# UNITED STATES PATENT AND TRADEMARK OFFICE

APPLICATION NO.	FILING DATE	FIRST NAMED INVENTOR	ATTORNEY DOCKET NO.	CONFIRMATION NO.
10/732,804	12/11/2003	Tae-Hec Cho	P-0622	5887
34610 7590 08/20/2007 KED & ASSOCIATES, LLP P.O. Box 221200 Chantilly, VA 20153-1200			EXAMINER ALEJANDRO, RAYMOND	
			ART UNIT 1745	PAPER NUMBER
			MAIL DATE 08/20/2007	DELIVERY MODE PAPER

# Office Action Summary

## **DETAILED ACTION**

FIG. 2  
CONVENTIONAL ART

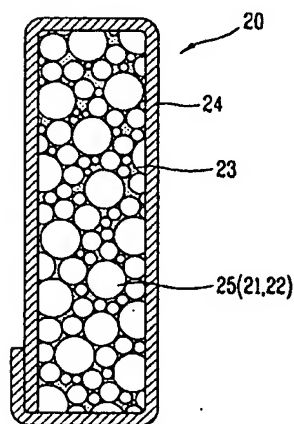
The AAPA makes known an electrode structure including a foam body 23 made of Ni in which mixture of electrode catalyst particles 21 made of metal halide (MH), and polytetrafluoroethylene 22 is infiltrated, and a mesh 24 made of Ni enclosing the foam body 23 (*See applicant's specification on page 3, lines 10-25/ FIGURE 2*).

The AAPA discloses in detail, a granule type electrode catalyst 21 and PTFE 22 mixed to a mixture 25 which is infiltrated in the foam body 23 to fill the void parts of the foam body 23; wherein the foam body 23 filled with the mixture 25 is enclosed by the mesh 24 which maintains the shape of the foam body 23 (*See applicant's specification on page 3, lines 10-25/ FIGURE 2*).

*In this case, it is contended that either or both the foam body 23 and the mesh 24 act(s) as the claimed catalyst holding body; yet further, infiltration of the electrode catalyst granule-PTFE mixture in the foam body 23 encompasses certain degree of entanglement or wrapping or twisting. Note that the term "entangle" only means to wrap or twist together (Merriam-Webster's Collegiate Dictionary 10<sup>th</sup> Edition) but does not suggest any specific material and/or structure.*

**Figure 2** below illustrates the conventional electrode structure disclosed by the applicant (See FIGURE 2).

The AAPA discloses a granule type electrode catalyst 21 (*See applicant's specification on page 3, lines 10-25/ FIGURE 2*).

The AAPA uses electrode catalyst particles 21 made of metal halide (MH) (*See applicant's specification on page 3, lines 10-25/ FIGURE 2*). It is noted that a metal halide is a hydrogen storage alloy.

The AAPA makes known an electrode structure including a foam body 23 made of Ni and a mesh 24 made of Ni enclosing the foam body 23 (*See applicant's specification on page 3, lines 10-25/ FIGURE 2*). In this case, it is contended that either or both the foam body 23 and the mesh 24 act(s) as the claimed catalyst holding body. Moreover, since the foam body 23 and the enclosing mesh are made of Ni, it is further contended that they represent a Ni-material contacting the electrode catalyst, thereby they serve as the claimed Ni layer.

The AAPA uses polytetrafluoroethylene 22 to make the electrode (*See applicant's specification on page 3, lines 10-25/ FIGURE 2*).

FIG. 2  
CONVENTIONAL ART

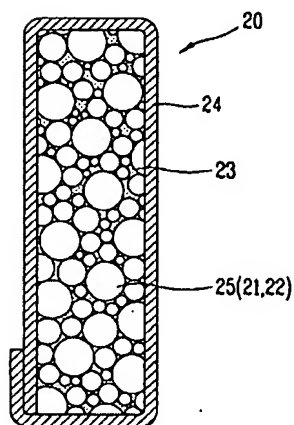
The AAPA makes known an electrode structure including a foam body 23 made of Ni in which mixture of electrode catalyst particles 21 made of metal halide (MH), and polytetrafluoroethylene 22 is infiltrated, and a mesh 24 made of Ni enclosing the foam body 23 (*See applicant's specification on page 3, lines 10-25/ FIGURE 2*).

The AAPA discloses in detail, a granule type electrode catalyst 21 and PTFE 22 mixed to a mixture 25 which is infiltrated in the foam body 23 to fill the void parts of the foam body 23; wherein the foam body 23 filled with the mixture 25 is enclosed by the mesh 24 which maintains the shape of the foam body 23 (*See applicant's specification on page 3, lines 10-25/ FIGURE 2*). *In this case, it is contended that either or both the foam body 23 and the mesh 24 act(s) as the claimed catalyst holding body; yet further, infiltration of the electrode catalyst granule-PTFE mixture in the foam body 23 encompasses certain degree of entanglement or wrapping or twisting. Note that the term "entangle" only means to wrap or twist together (Merriam-Webster's Collegiate Dictionary 10<sup>th</sup> Edition) but does not suggest any specific material and/or structure.*

**Figure 2** below illustrates the conventional electrode structure disclosed by the applicant (See FIGURE 2).

The AAPA discloses a granule type electrode catalyst 21 (*See applicant's specification on page 3, lines 10-25/ FIGURE 2*).

The AAPA uses electrode catalyst particles 21 made of metal halide (MH) (*See applicant's specification on page 3, lines 10-25/ FIGURE 2*). *It is noted that a metal halide is a hydrogen storage alloy.*

The AAPA makes known an electrode structure including a foam body 23 made of Ni and a mesh 24 made of Ni enclosing the foam body 23 (*See applicant's specification on page 3, lines 10-25/ FIGURE 2*). *In this case, it is contended that either or both the foam body 23 and the mesh 24 act(s) as the claimed catalyst holding body. Moreover, since the foam body 23 and the enclosing mesh are made of Ni, it is further contended that they represent a Ni-material contacting the electrode catalyst, thereby they serve as the claimed Ni layer.*

The AAPA uses polytetrafluoroethylene 22 to make the electrode (*See applicant's specification on page 3, lines 10-25/ FIGURE 2*).
